Product Change Notification / ASER-19HIWO872

CCB 4748 Final Notice: Qualification of MTAI as an additional assembly site for selected ATMEGA324PBxxx and PIC16F1527xxx device families available in 44L TQFP (10x10x1mm) package.

**CCB 4748**  
**Pre and Post Change Summary**  
**PCN #: ASER-19HIWO872**

# Lead Frame Comparison

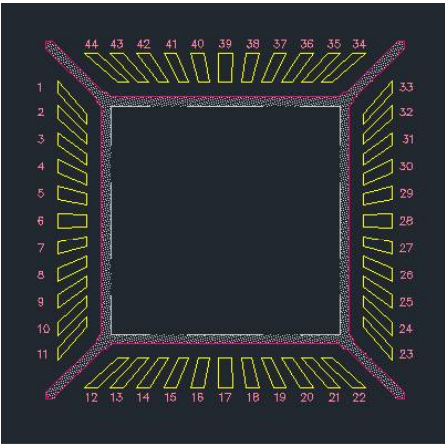
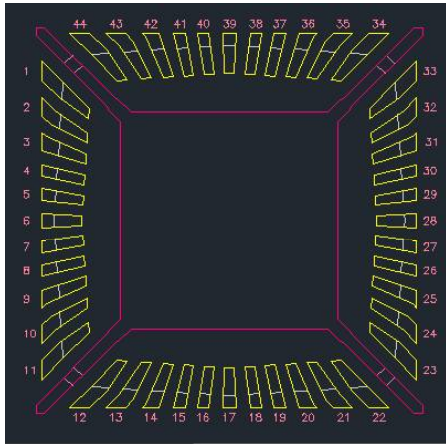
ASCL		MTAI	
 <p>The ASCL lead frame diagram shows a square frame with 44 numbered leads (1-11 on the left, 12-22 on the bottom, 23-33 on the right, and 34-44 on the top). The leads are relatively wide and have a distinct trapezoidal shape.</p>		 <p>The MTAI lead frame diagram shows a square frame with 44 numbered leads (1-11 on the left, 12-22 on the bottom, 23-33 on the right, and 34-44 on the top). The leads are narrower and more closely spaced than the ASCL frame.</p>	
<b>Material</b>	EFFECT64	<b>Material</b>	C7025
<b>Paddle Size</b>	205 x 205 mils	<b>Paddle Size</b>	180 x 180 mils
<b>DAP Surface Prep</b>	Ag ring plate	<b>DAP Surface Prep</b>	Bare copper
